Project Name: Timberline Aviation

REVIEW COMMENTS

FILE # SPR-96-161

TITLE HEADING: Site Plan Review -
Timberline Aviation

| SITE PLAN |

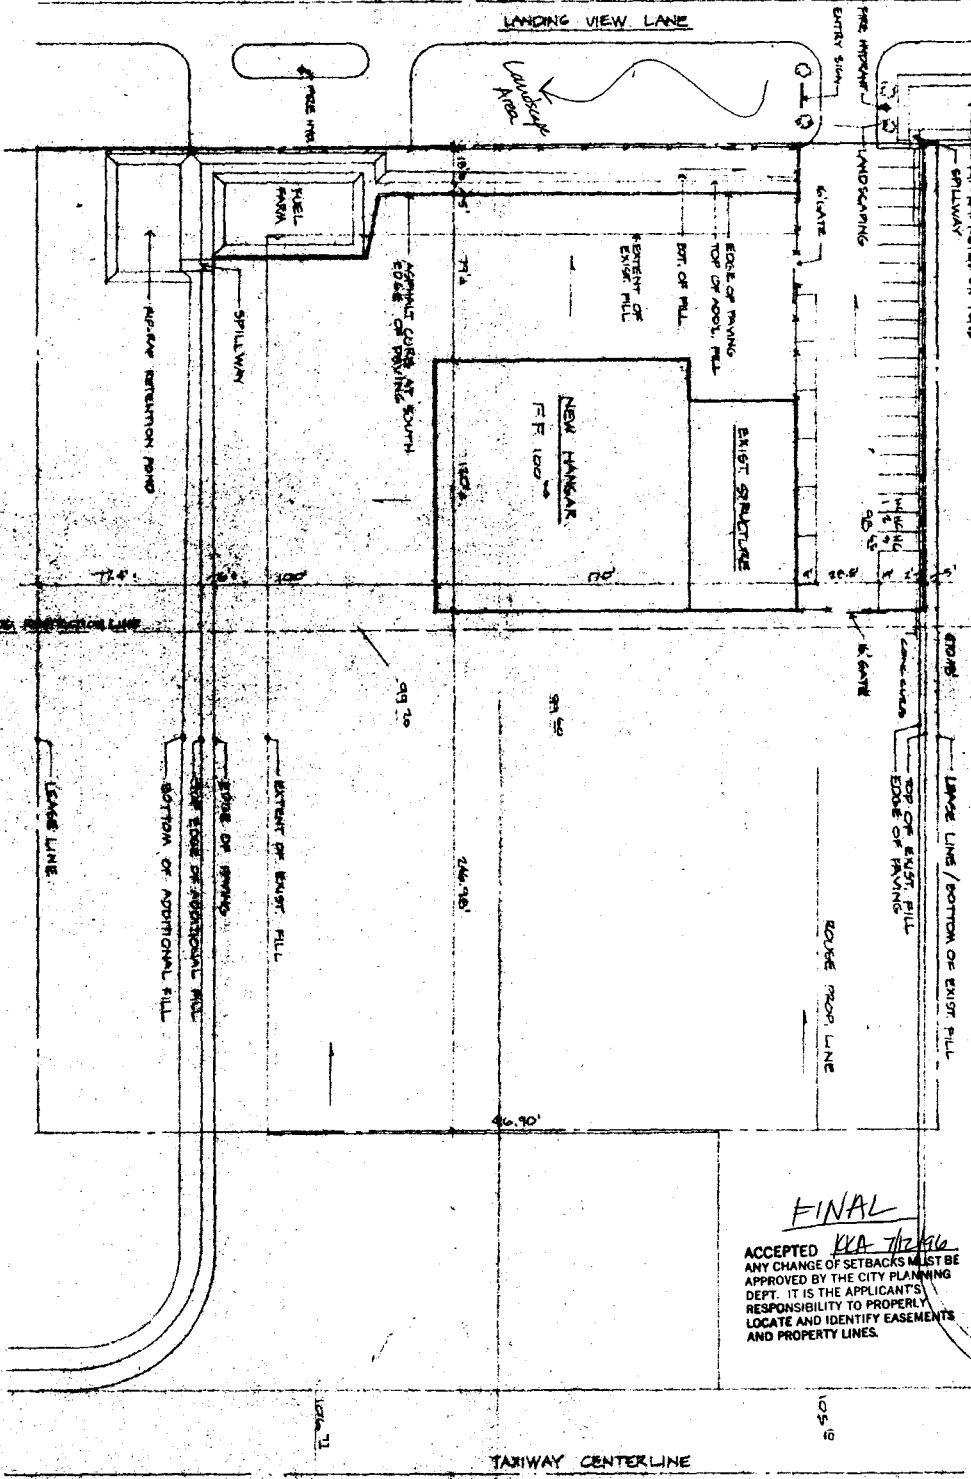
1. "Existing building" doesn't exist (?) Which building is already under construction, the hangar or the "existing building"?
2. Proposed development extends beyond boundary of ground lease with Airport. Provide a copy of agreement with adjacent property to the west.

1. According to project narrative, only 25 parking spaces are required (7,500 sf office @. 1 space/300 gsf). What are the additional 37 spaces for?
2. If parking exceeds 50 spaces (as shown on plan submitted), it must meet all requirements of section 5-5-1F. of the Zoning and Development Code regarding landscaping and lighting.
3. Parking lot does not meet ADA standards (3 accessible stalls required).
4. Curbing is required around edge of parking areas (not shown).

1. Identify species, numbers and planting size of plants (trees - minimum 1.5" caliper, shrubs - minimum 5 gallon).
2. Identify ground cover (e.g. grass, plants) in all landscape areas).
3. Add note on plan indicating all landscape areas will have underground pressurized irrigation system.

1. Please provide spot elevations on the site plan and provide floor elevations for the building.
2. Please provide dimensions and volumes of the retention ponds along with calculations of the runoff and necessary retention volume.

FINAL
 ACCEPTED *KPA 7/12/96*
 ANY CHANGE OF SETBACKS MUST BE APPROVED BY THE CITY PLANNING DEPT. IT IS THE APPLICANT'S RESPONSIBILITY TO PROPERLY LOCATE AND IDENTIFY EASEMENTS AND PROPERTY LINES.

Proposed Grading and Drainage Plan

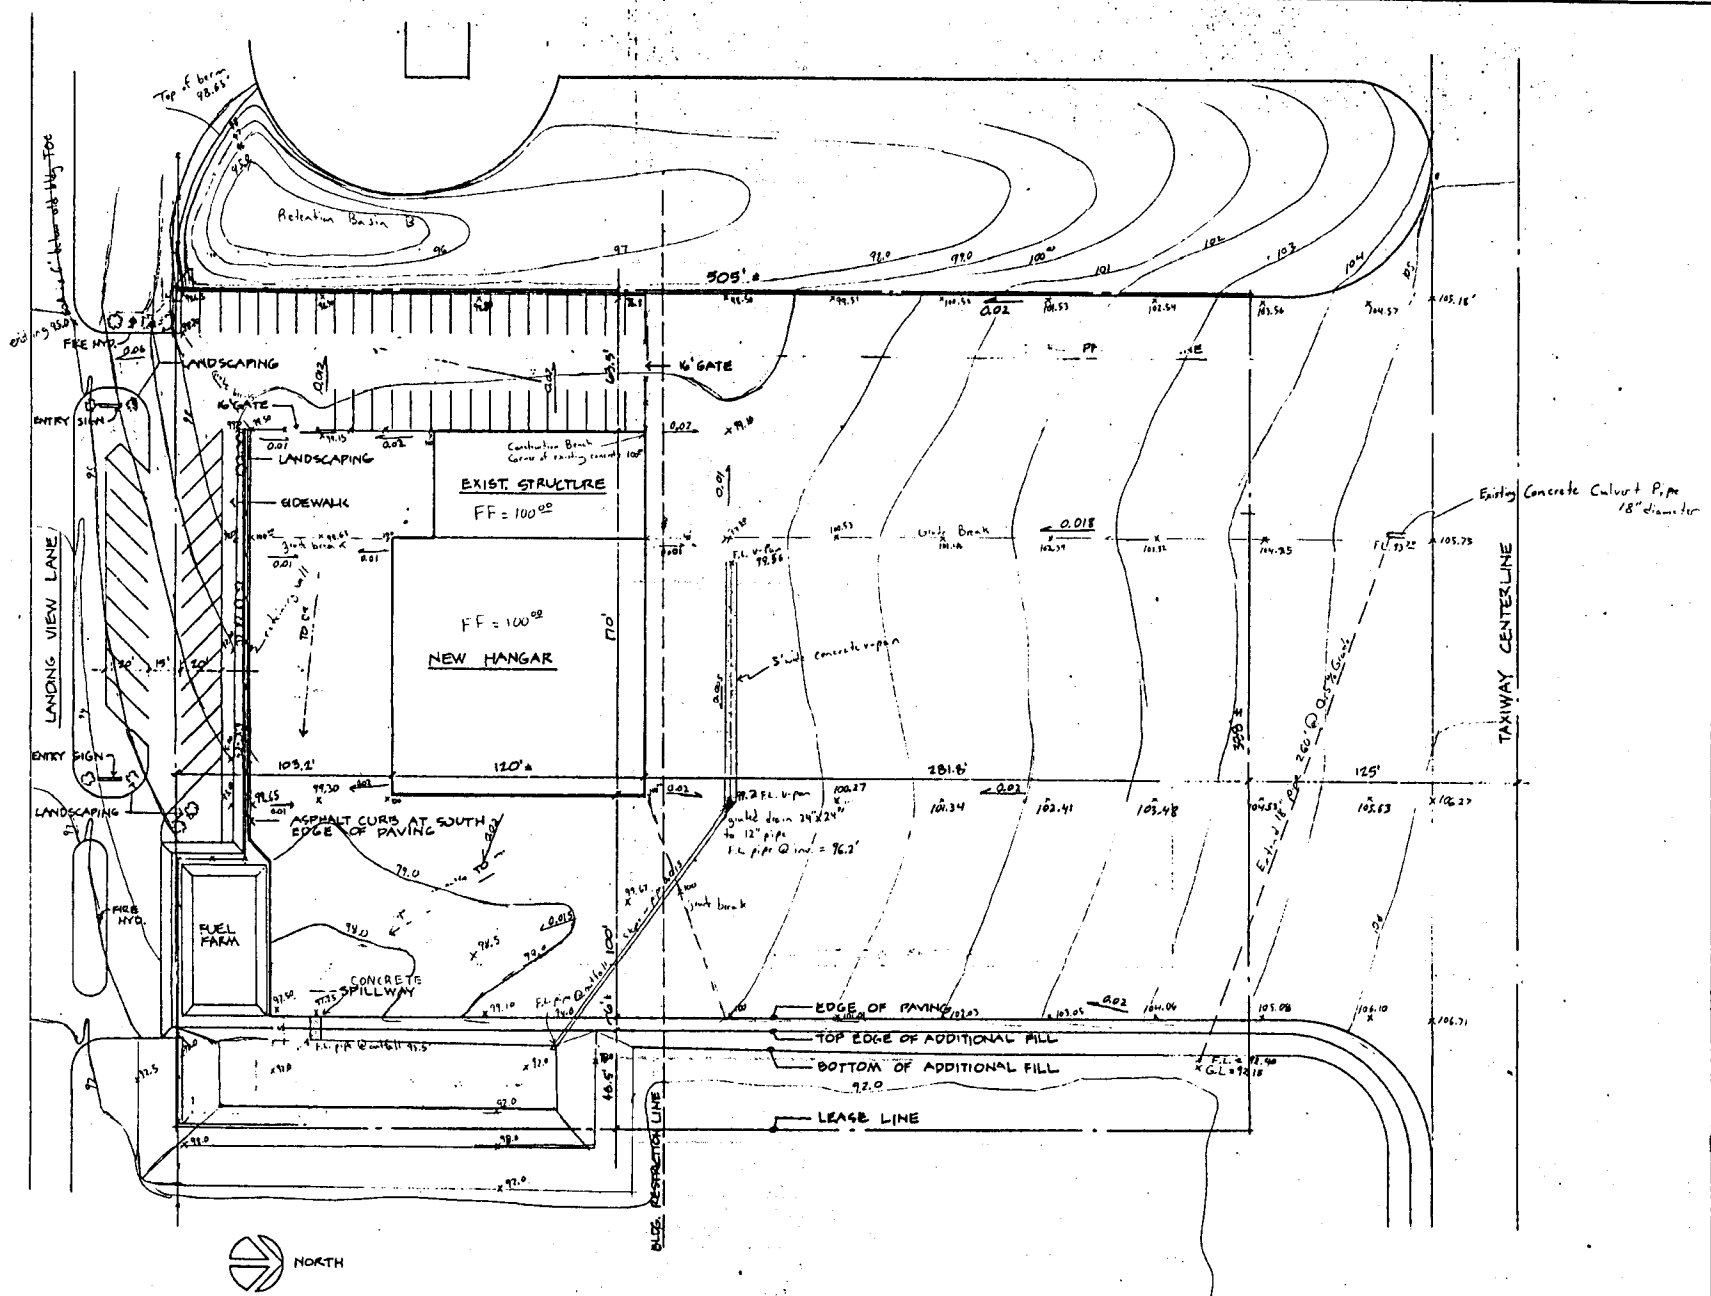
The Walker Field Airport Authority has reviewed the proposed building plans submitted by Timberline Aviation. The Airport Authority has no objections to any of the proposed development. The only outstanding item to be addressed by Timberline is a stormwater drainage plan however the Airport will not require immediate submittal of this and will allow construction on the building and site to begin without formal submittal of the drainage plan.
